11301 FIRMWARE REPLACEMENT

11301 All Serial Numbers

MANUAL CHANGE INFORMATION

Date: 18-Jan-90 Change Reference: M70209 Rev-1

Figure 2-74. Measurement choices shown above.

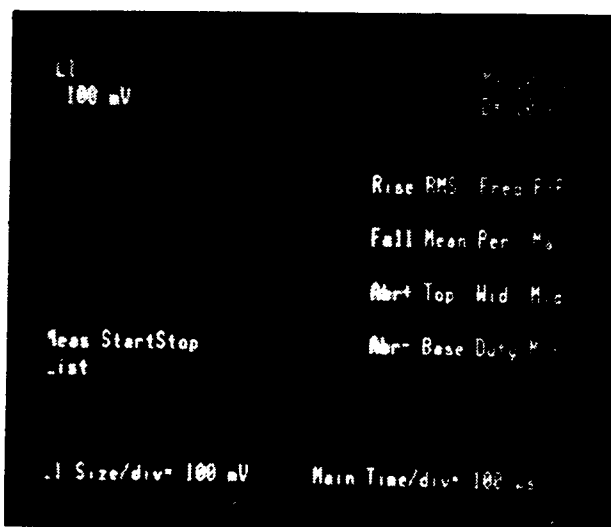
Add this new display to page 2-151:

The MEASURE major menu display has been changed as shown below:

Add the following text to page 2-152:

MEASUREMENT MENU, when auto measurements of rise time and fall time are being made, and the signal that is being measured is too fast or too noisy, the following statements will appear. In the place of the rise time or fall time the statements **too fast** or **too noisy** will be displayed.

Figure 2-79. Non-volatile stored settings menu selections.

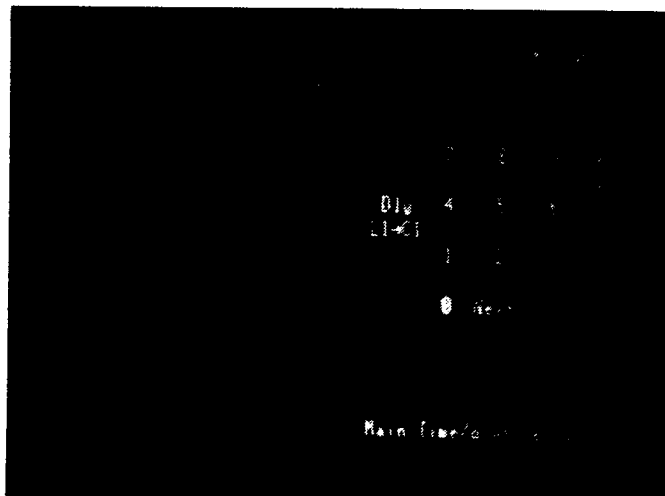
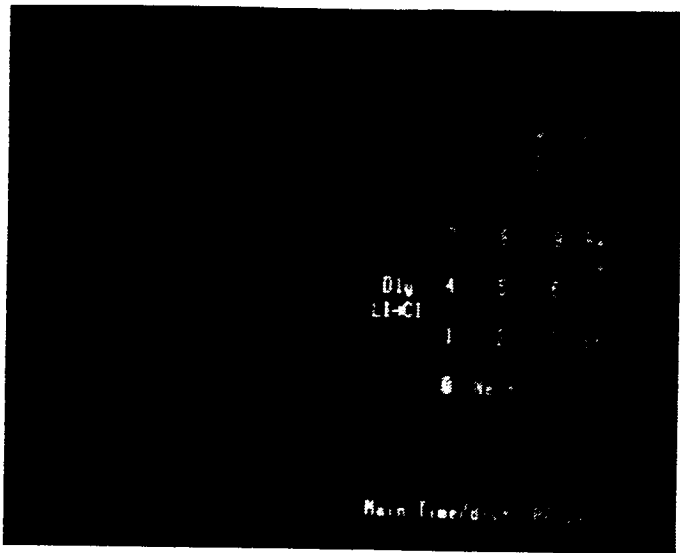
Add this new display to page 2-162:
The STORE RECALL major menu display has been changed as shown below:

Add this new feature to page 2-162, 070-6106-00
Add this new feature to page 2-163, 070-7175-00

Dly
L1—»C1

When L1—»C1 is selected on the store recall menu the scope will automatically setup to measure prop delay between signals on the left CH 1 and center CH 1. When this command is initiated the present scope setup will be lost.
